Änderungsmitteilung (CN)

Product Change Notification

Title [Title] Power supply label update		Date [Datum] 03.Jul.2025		Ref. No. [Lfd. Nr.] CN_25_003	
Part Name [Teilebezeichnung]	RRC Article No. [RRC Art-Nr.]	Index	Customer Article No. [Kunden Art-Nr.]	Index	
RRC-SMB-HBC	110311	-03

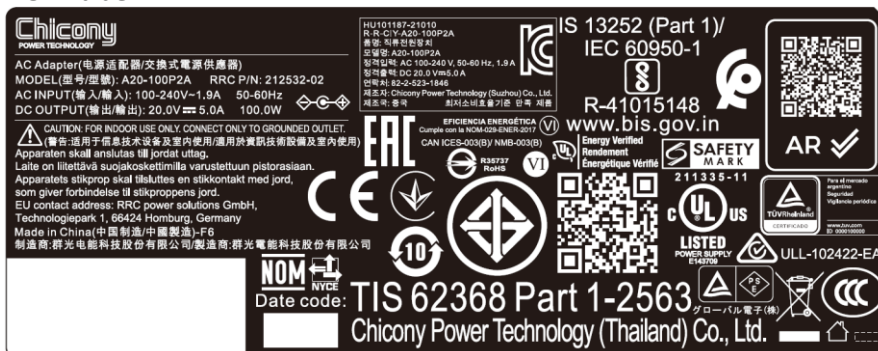
The device label of the 100W power supply that is part of the RRC-SMB-HBC bundle has been updated:

The part's serial number will be available via a QR code provided in the white field (left bottom corner).

The revision step of the charger product number (110311-03) ensures traceability. See the device label on the charger cradle and the paper label on the single box for each charger as well as on the outer box for 12 chargers.
